**PCN# 20150211000C**  
**Qualification of Carrier Tape for 14/16 pin SOP**  
**and 28 pin SSOP device**  
**Change Notification / Sample Request**

**Date:** 4/9/2015  
**To:** Newark/Farnell PCN

<b>PCN Number:</b>	20150211000C		<b>PCN Date:</b>	04/09/2015																						
<b>Title:</b>	Qualification of Carrier Tape for 14/16 pin SOP and 28 pin SSOP device																									
<b>Customer Contact:</b>	<a href="#">PCN Manager</a>	<b>Dept:</b>	Quality Services																							
<b>Change Type:</b>																										
<input type="checkbox"/>	Assembly Site	<input type="checkbox"/>	Design	<input type="checkbox"/>	Wafer Bump Site																					
<input type="checkbox"/>	Assembly Process	<input type="checkbox"/>	Data Sheet	<input type="checkbox"/>	Wafer Bump Material																					
<input type="checkbox"/>	Assembly Materials	<input type="checkbox"/>	Part number change	<input type="checkbox"/>	Wafer Bump Process																					
<input type="checkbox"/>	Mechanical Specification	<input type="checkbox"/>	Test Site	<input type="checkbox"/>	Wafer Fab Site																					
<input checked="" type="checkbox"/>	Packing/Shipping/Labeling	<input type="checkb

## Appendix A: Tape Design comparison Current Tape

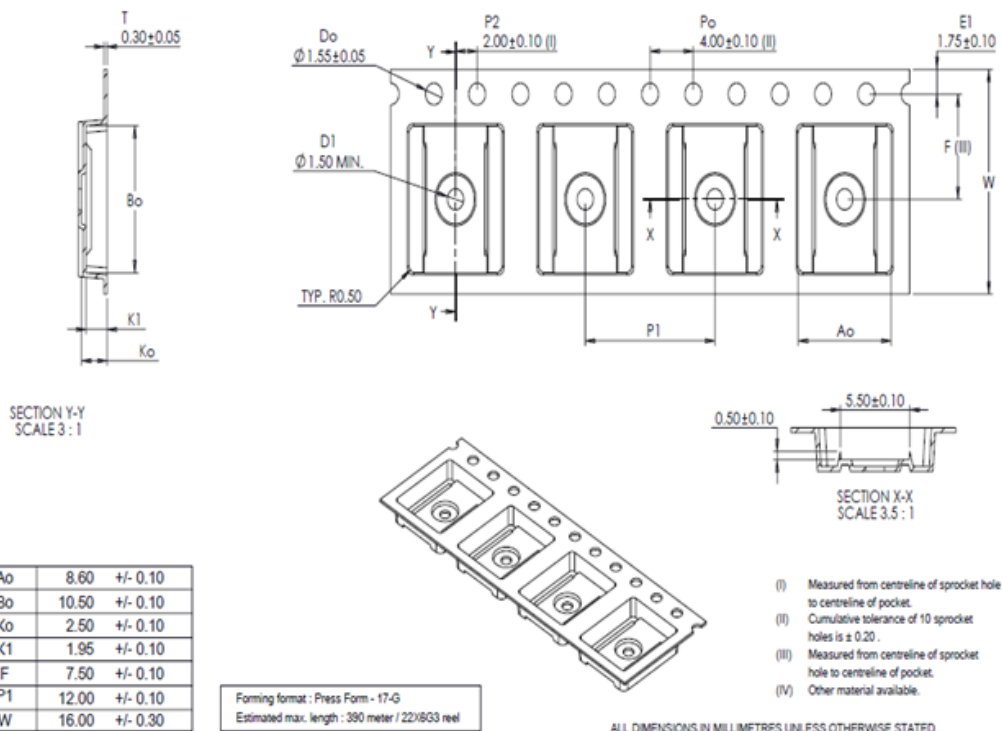
<table><tr> <th>Item</th> <th>Current</th> <th>Proposed</th> </tr><tr> <td>Dimension (detail comparison in table 2 in sheet 4)</td> <td>A0 = 8.10mm ± 0.1 B0 = 10.40mm ± 0.1 K0 = 2.50mm ± 0.1 K1 = 2.10mm ± 0.1 W = 16.00mm ± 0.3</td> <td>A0 = 8.60mm ± 0.1 B0 = 10.50mm ± 0.1 K0 = 2.50mm ± 0.1 K1 = 1.95mm ± 0.1 W = 16.00mm ± 0.3</td> </tr></table>

Item	Current	Proposed	Supplier	<u>Cpak</u>	<u>Cpak</u>	Material	Polystyrene	Polystyrene	Color	Black	Black	Dimension (detail comparison in table 2 in sheet 4)	A0 = 8.10mm ± 0.1 B0 = 10.40mm ± 0.1 K0 = 2.50mm ± 0.1 K1 = 2.10mm ± 0.1 W = 16.00mm ± 0.3	A0 = 8.60mm ± 0.1 B0 = 10.50mm ± 0.1 K0 = 2.50mm ± 0.1 K1 = 1.95mm ± 0.1 W = 16.00mm ± 0.3	Surface resistivity	Between 1.01x 10 <sup>5</sup> to 8.12 x 10 <sup>5</sup>	Between 1.54x10 <sup>5</sup> to 5.37 x 10 <sup>6</sup>	Part number	4135168-0070	4212589-0026
Item	Current	Proposed																								
Supplier	<u>Cpak</u>	<u>Cpak</u>																								
Material	Polystyrene	Polystyrene																								
Color	Black	Black																								
Dimension (detail comparison in table 2 in sheet 4)	A0 = 8.10mm ± 0.1 B0 = 10.40mm ± 0.1 K0 = 2.50mm ± 0.1 K1 = 2.10mm ± 0.1 W = 16.00mm ± 0.3	A0 = 8.60mm ± 0.1 B0 = 10.50mm ± 0.1 K0 = 2.50mm ± 0.1 K1 = 1.95mm ± 0.1 W = 16.00mm ± 0.3																								
Surface resistivity	Between 1.01x 10 <sup>5</sup> to 8.12 x 10 <sup>5</sup>	Between 1.54x10 <sup>5</sup> to 5.37 x 10 <sup>6</sup>																								
Part number	4135168-0070	4212589-0026																								
<b>Reason for Change:</b>																										
Continuity of Packaging. Tape Side pocket reflection causing high rejection rate on lead abnormality during Tape and Reel process																										
<b>Anticipated impact on Form, Fit, Function, Quality or Reliability (positive / negative):</b>																										
None																										
<b>Changes to product identification resulting from this PCN:</b>																										
None																										
<b>Product Affected Group 1: Retracted Devices</b>
